CASE:
 Z14-059

PROJECT:
 BELLAGIO BROWN RD - MONTECITO

Planning and Zoning Board

Case Information

SITE PLAN
 MONTICELLO

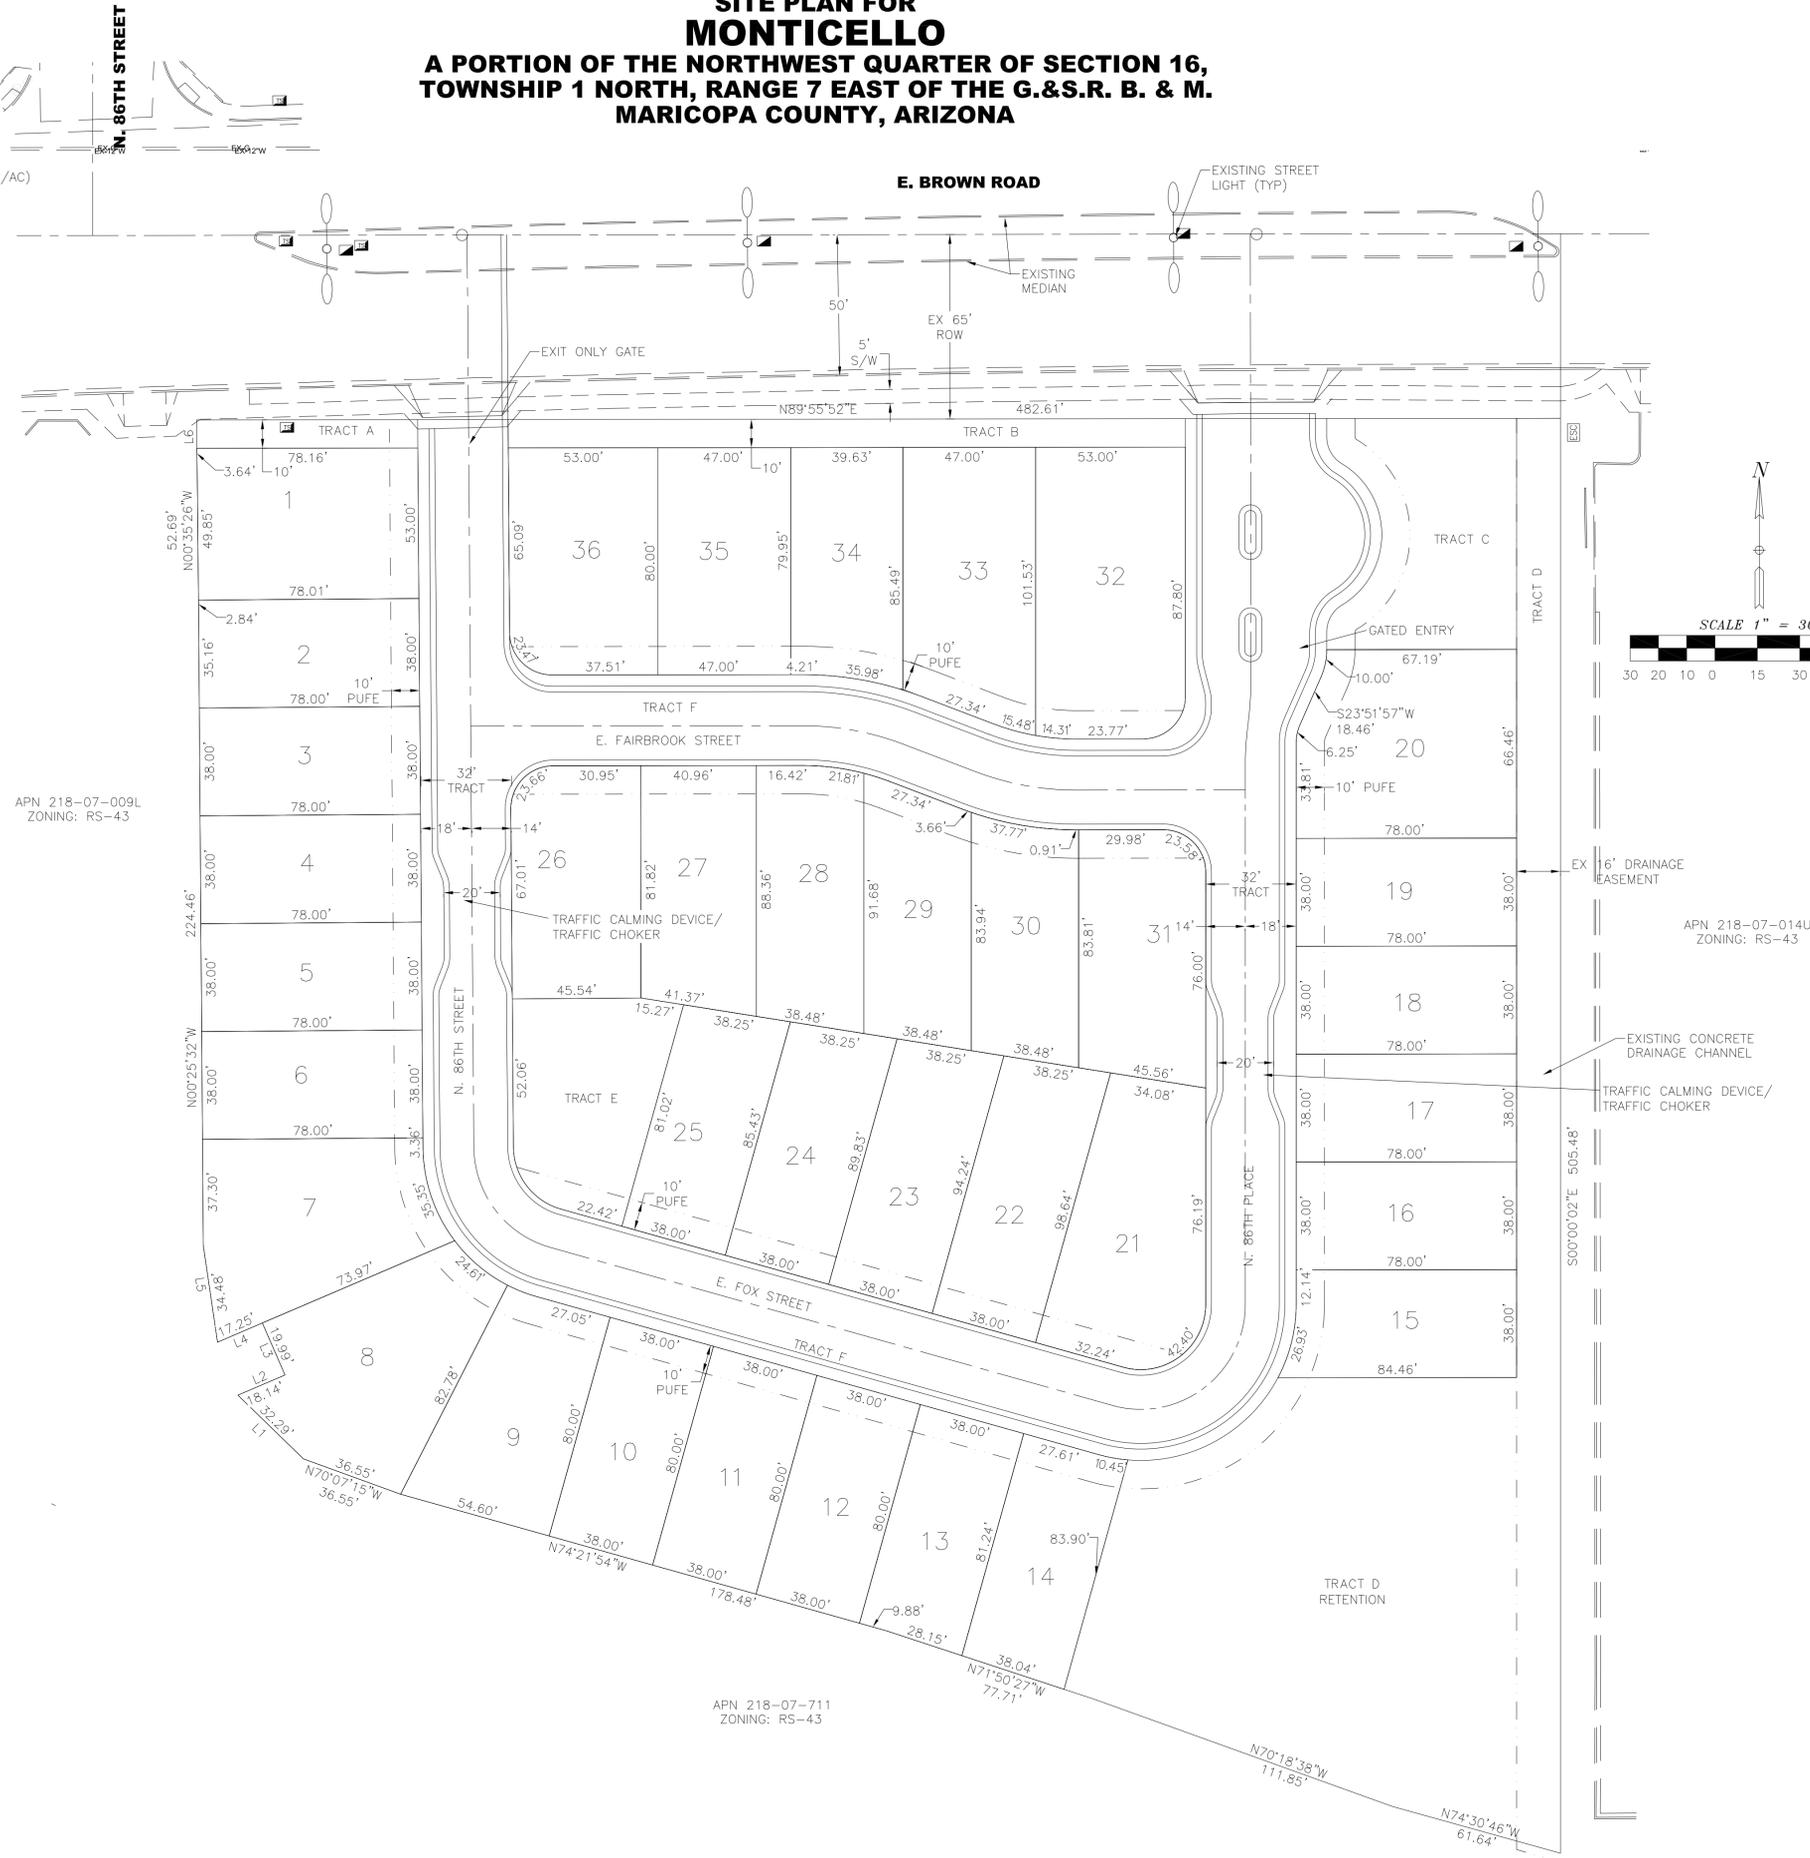
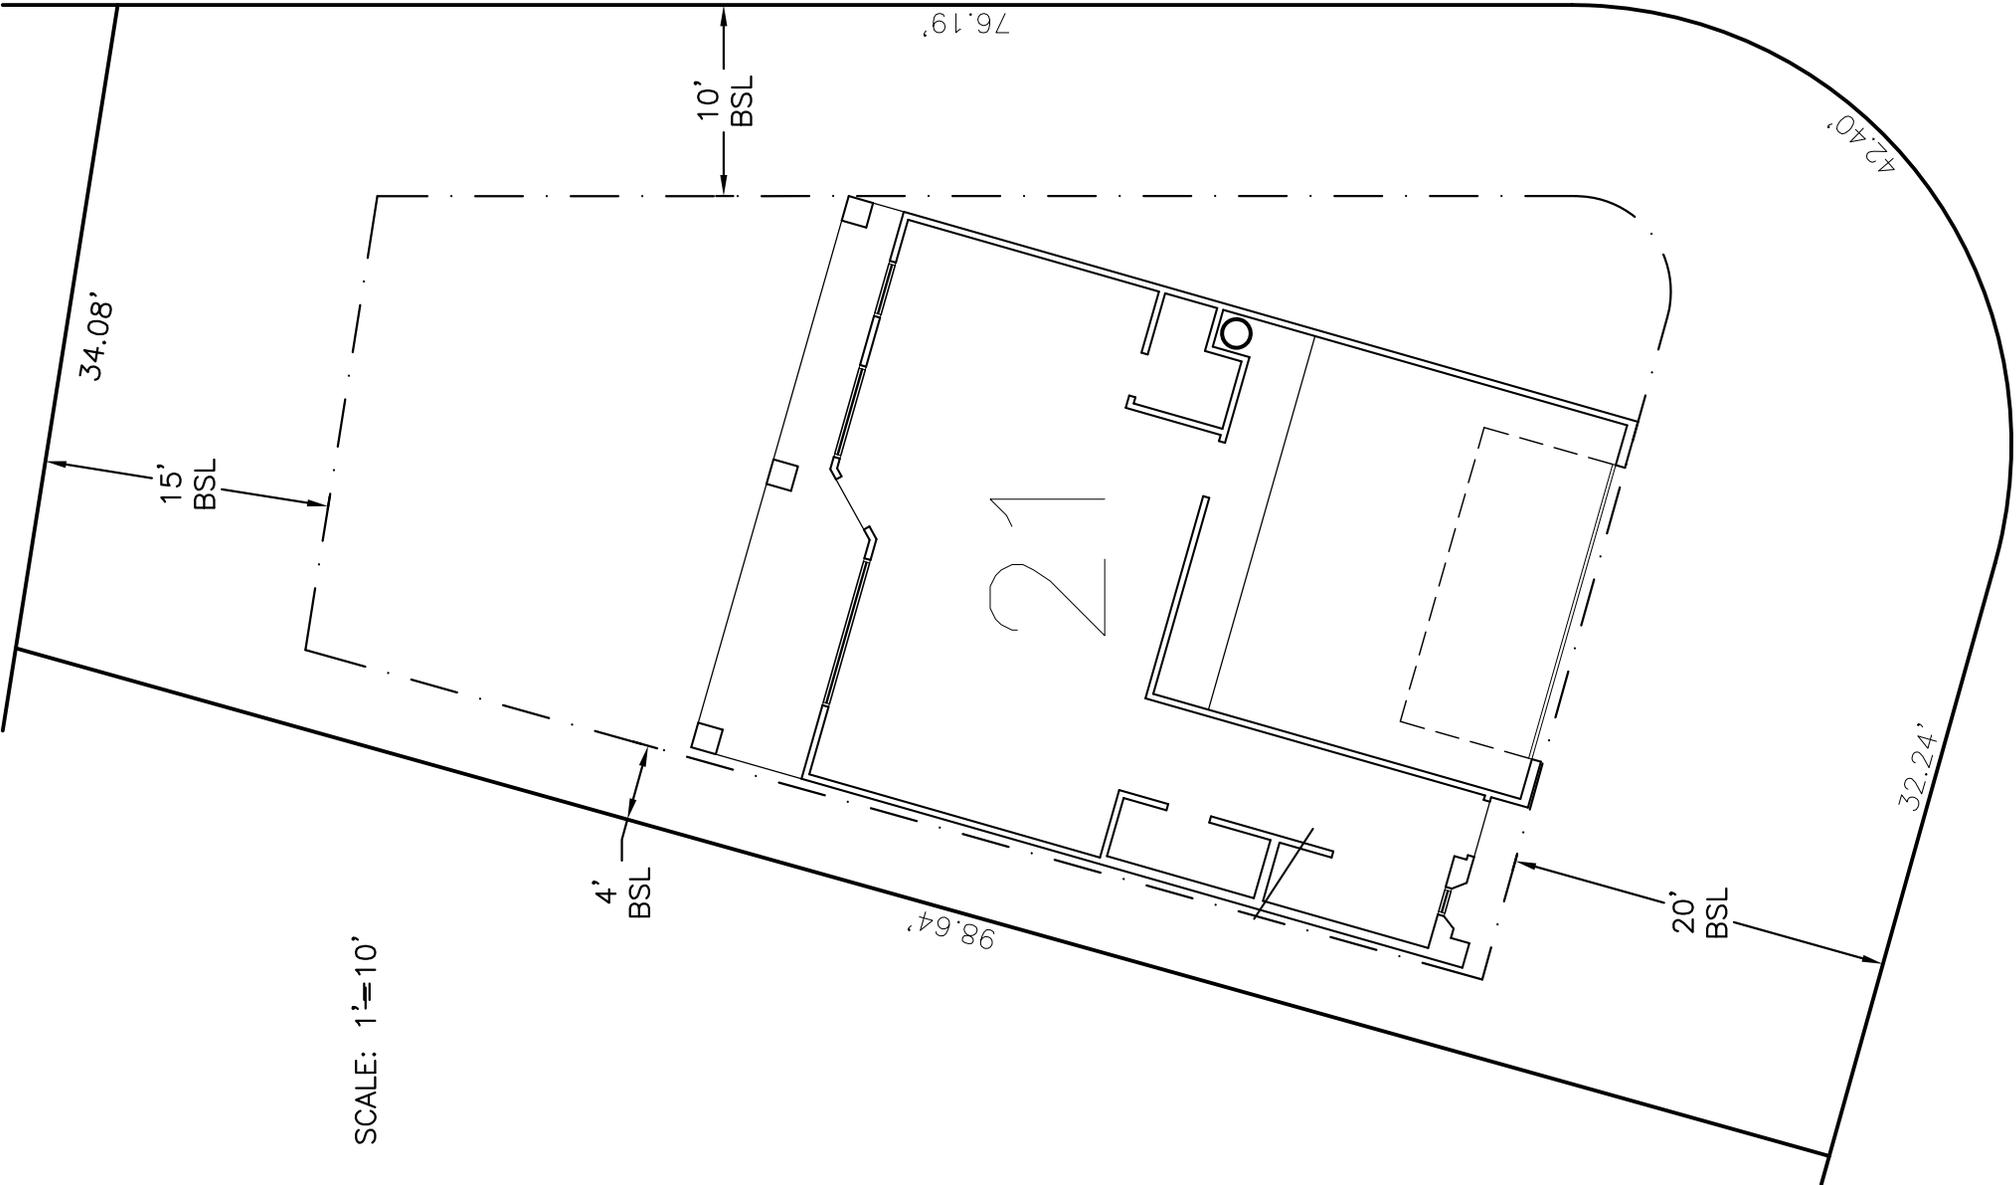
In reviewing the overall plan as previously noted the lots and layout are typical or conventional. The site plan indicates 18.8% of open space, with a pool proposed on a separate 3,712 square foot tract and a retention area at the southeast corner of the development, which is 27,137 square feet in area. The larger open space area is pinched off from the street with the sides of homes, which limits visibility into this area. Staff has commented about fronting lots on the open space to provide natural surveillance and begin to create spaces that the community would naturally gather. Staff also raised concerns that a 36 lot subdivision would not be able to support a pool as an amenity long term. The applicant is confident that the number of lots is sufficient to support a small pool area and that the location of the open space is appropriate with lots siding onto it. One alternative would be to relocate Tract E, which contains the pool to the location on the site plan identified as lot 21. Grouping the two open space areas would create a central area for neighbors to gather and interact, allowing families to enjoy all of the amenities without being in separate locations.

Within the open space design for the larger retention area, there is reference to shaded seating with benches. More details have not been provided, but it seems as though staff would caution that the amount of shade and seating be sufficient for gathering. Shade structures are essential in making these opens space areas truly useable and a place to hang out and start to create the place for the community to start to congregate.

7. **Relocation of the pool open space area to lot 21 so that it is located more closely to the larger open space retention area with an enhanced pavement surface between the two open space areas.**

PLAN 1013
MONTICELLO

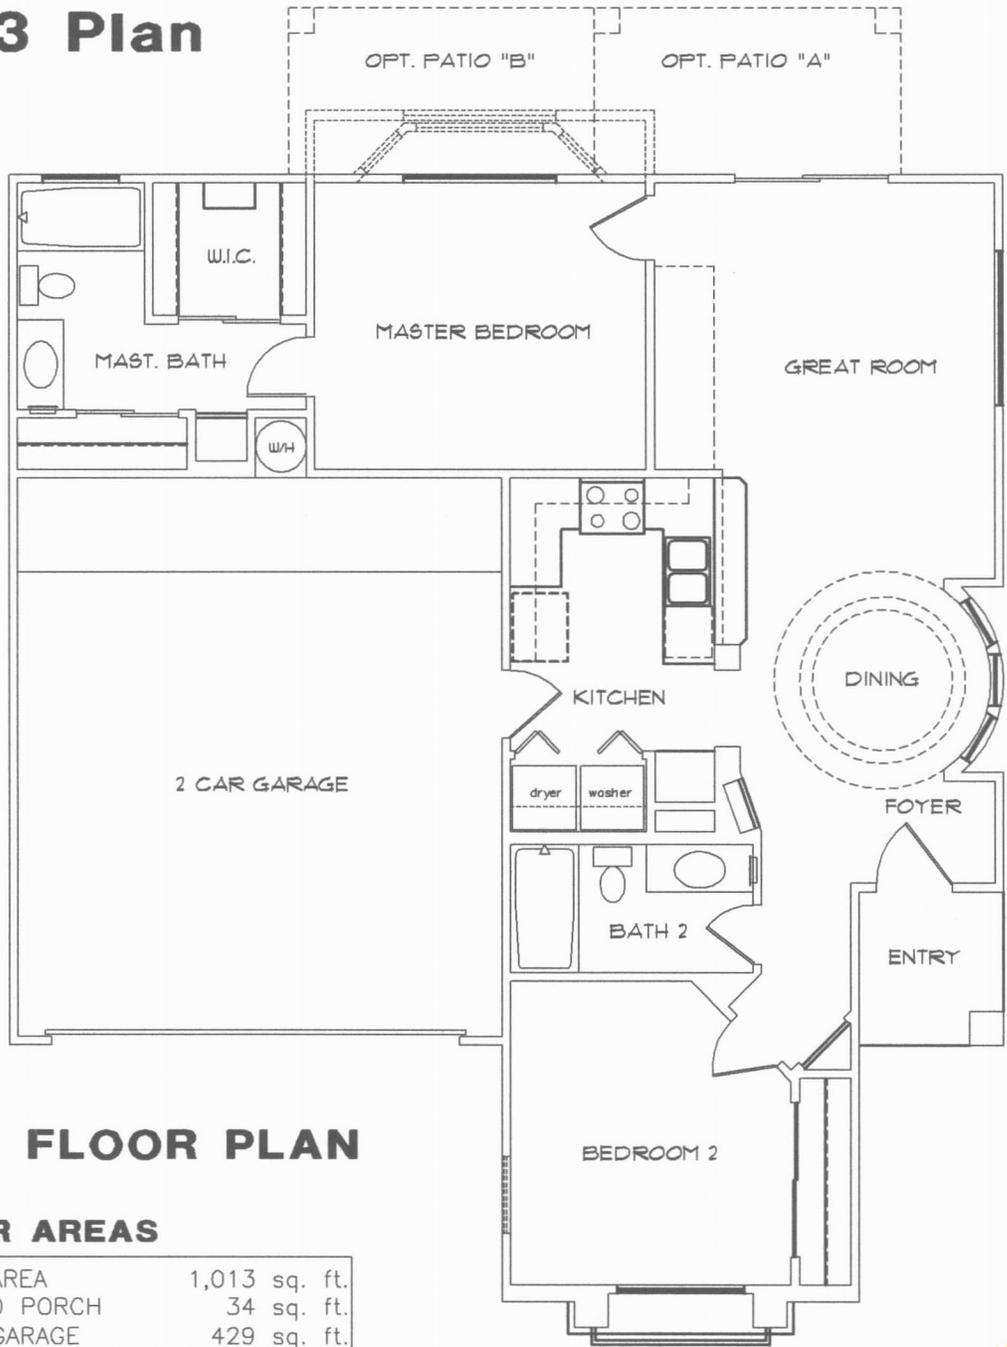
In review of the housing product design for the project it is apparent that the product design is not in conformance with the Building Form standards established in the Zoning Ordinance, which are intended to minimize the garagescape appearance of our residential streets and to bring the livable area with porches closer to the street to activate the front of the house and the neighborhood. In review of the floor plans submitted, it seems as though some fairly minor adjustments could be made to the product to comply with these standards. In order to ensure the necessary proportions and variations, Staff has added a condition of approval requiring Administrative Product Approval by the Planning Director. During that review, staff will continue working with the applicant to ensure high quality elevations.

6. **The house plans submitted do not comply with the Building Form Standards established in section 11-5-7(D) of the City of Mesa Zoning Ordinance. Residential product is not included as part of this approval and must be submitted for administrative review and approval by the Planning Director. Compliance with section 11-5-7(D) is required.**
